40-1165FK vs 40-1339FK

IJS GROUP supplies two kits: 40-1165FK and 40-1339FK. The two kits look very similar, but they differ in the timing chains and some guides. For this reason, it is important to check the attached details with OE numbers to ensure correct application.

CHAIN + GUIDE

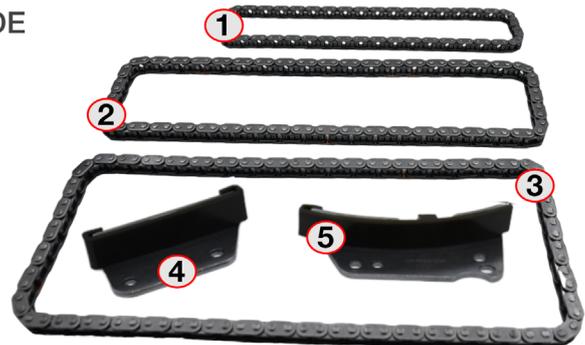
DIFFERENCE

40-1165FK

40-1339FK

- 1 - 24351-4A020 → CHAIN
- 2 - 24361-4A020 → CHAIN
- 3 - 23351-4A020 → CHAIN
- 4 - 23367-4A030 → GUIDE
- 5 - 24377-4A030 → GUIDE

- 1 - 24351-4A600 → CHAIN
- 2 - 24361-4A600 → CHAIN
- 3 - 23351-4A600 → CHAIN
- 4 - 23367-4A100 → GUIDE
- 5 - 24377-4A200 → GUIDE
